ATTACHMENT I TO IPN-96-092

**PROPOSED TECHNICAL SPECIFICATION CHANGES ASSOCIATED WITH THE
INCREASE OF FUEL ENRICHMENT TO 5.0 WEIGHT PERCENT URANIUM-235**

NEW YORK POWER AUTHORITY
INDIAN POINT 3 NUCLEAR POWER PLANT
DOCKET NO. 50-286
DPR-64

**SAFETY EVALUATION OF THE
PROPOSED TECHNICAL SPECIFICATION CHANGES ASSOCIATED WITH THE
INCREASE OF FUEL ENRICHMENT TO 5.0 WEIGHT PERCENT URANIUM-235**

Figure 3.8-1
Spent Fuel Pit Region 1 Type Definition

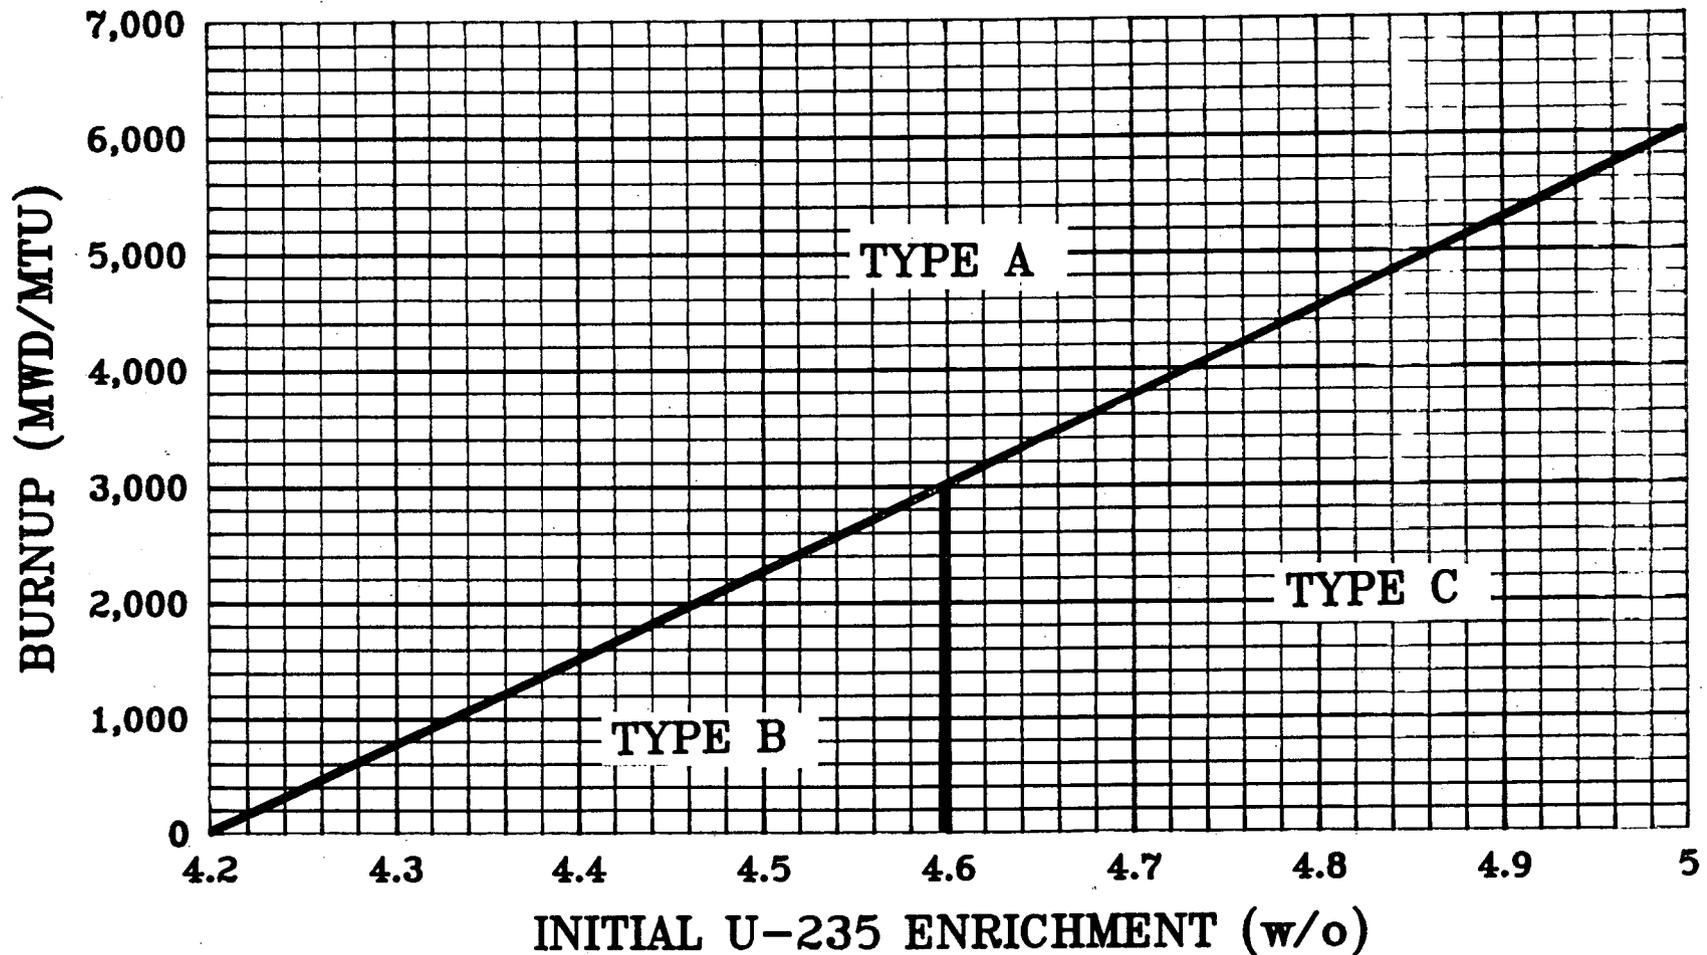
- a. As specified in Figure 3.8-2, fuel assemblies to be stored in Region 2 shall have a minimum burnup exposure as a function of initial enrichment.
 - b. As specified in Figure 3.8-1, fuel assemblies to be stored in Region 1 consist of 3 types (Type A, B, C), depending on their initial enrichment and current burnup. Restrictions on location of fuel in Region 1 are as follows:

1. Type A assemblies may be stored anywhere in Region 1.
 2. A Type B assembly may be stored anywhere in Region 1, provided it is not face-adjacent to a Type C assembly.

3. Type C assemblies may not be stored in Row 64 or Column ZZ of Region 1. A Type C assembly may be stored in any other Region 1 location provided that all surrounding (face-adjacent) locations are occupied by Type A assemblies, non-fuel components or empty.

The Region 1 area has also been analyzed for storage of high-enrichment and low-burnup fuel. Figure 3.8-1 categorizes Region 1 fuel assemblies as a function of their initial enrichment and current burnup into Types A, B, and C. Each type has different restrictions as to how it may be stored in Region 1. The least reactive assemblies, which are Type A assemblies, may be stored anywhere in Region 1. The most reactive assemblies, which are Type C assemblies, are stored only in Region 1 with the restrictions of Technical Specification 3.8.C.7.b.3, due to their high reactivity. Type C assemblies cannot be stored face-adjacent to anything more reactive than Type A fuel assemblies. There are no additional restrictions defining storage requirements for diagonally-adjacent fuel assemblies in Region 1. In addition, to prevent a criticality interaction with Region 2 fuel assemblies, Type C assemblies cannot be stored in Column ZZ or Row 64.

The following criteria should be used to categorize Region 1 fuel assemblies. Unburned fuel assemblies at or below 4.2 w/o enrichment are Type A. Unburned fuel assemblies at or below 4.6 w/o enrichment (but greater than 4.2 w/o enrichment) are Type B. Fuel assemblies whose burnup puts them on or above the diagonal line below the Type A zone are defined as Type A.

Figure 3.8-2

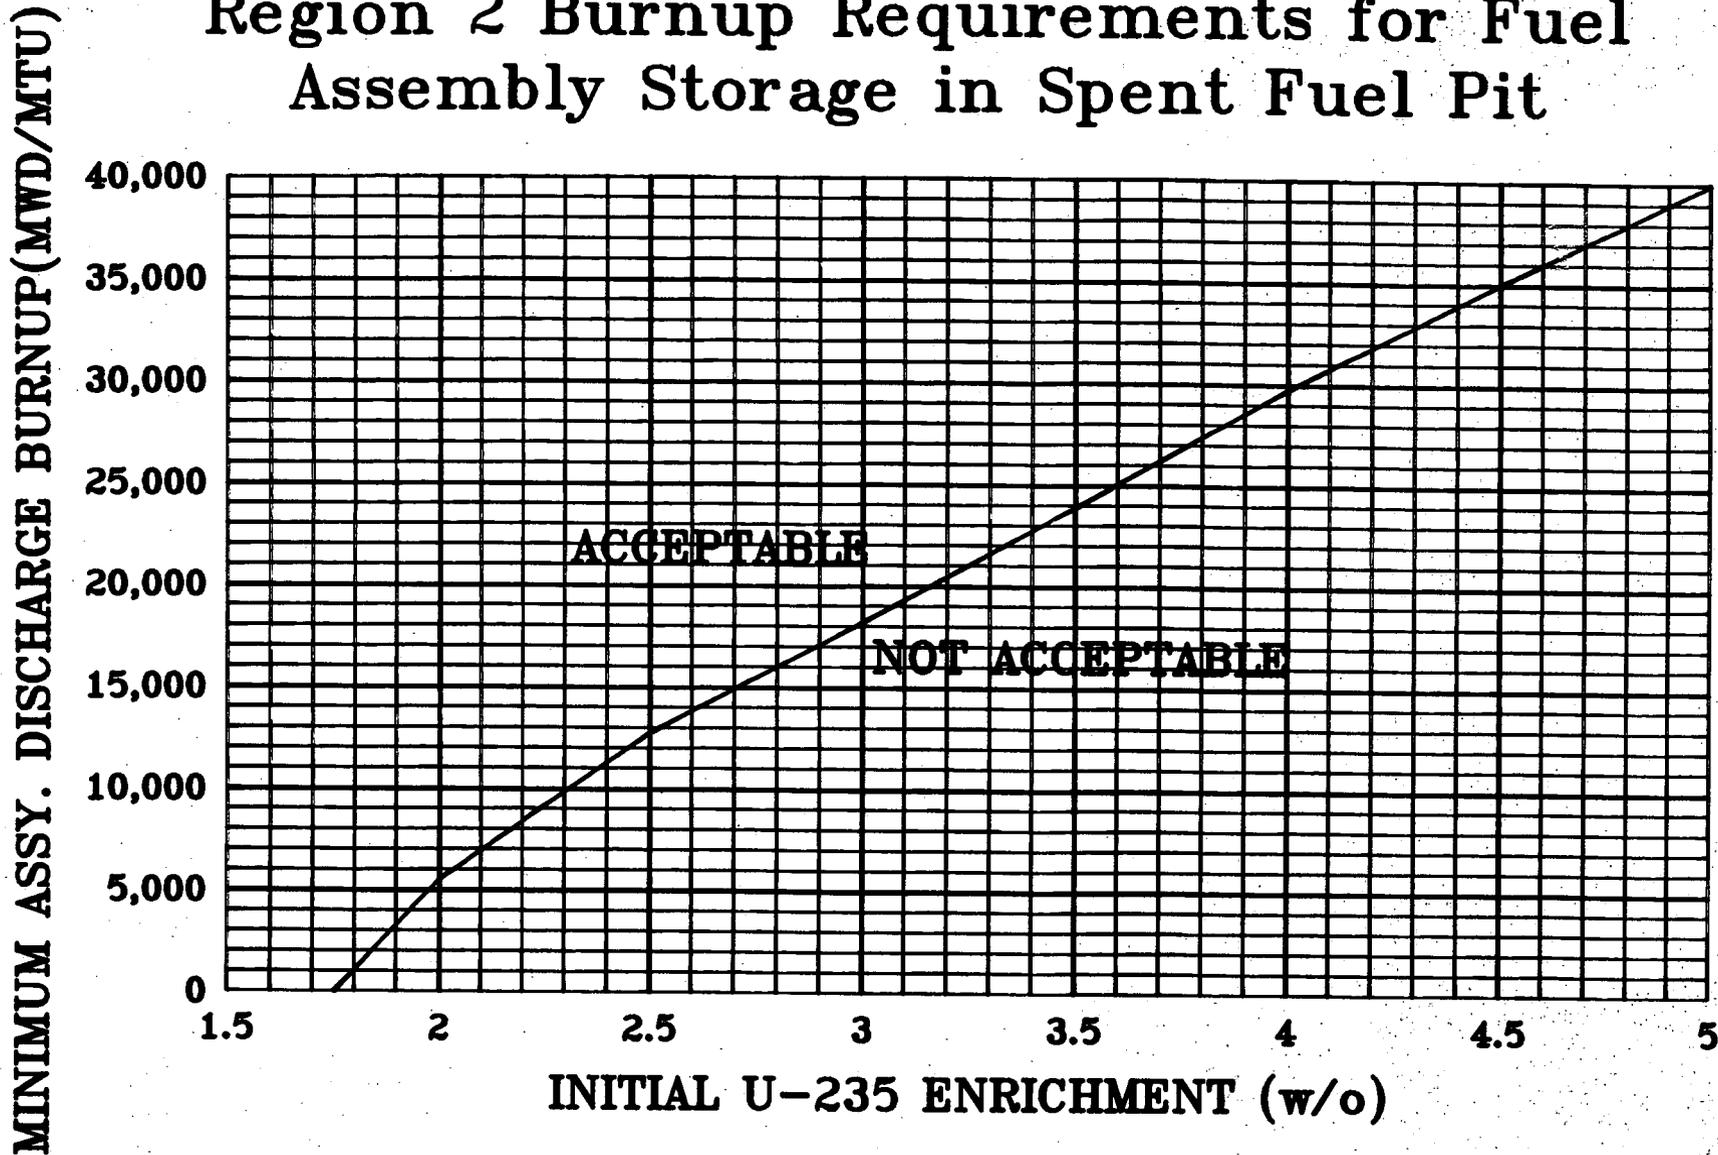
Fuel assemblies to be stored in Region 2 of the spent fuel racks must have a minimum burnup exposure as a function of initial enrichment as specified in Figure 3.8-2. Administrative controls will provide verification that each fuel assembly to be placed in Region 2 satisfies the burnup criterion.
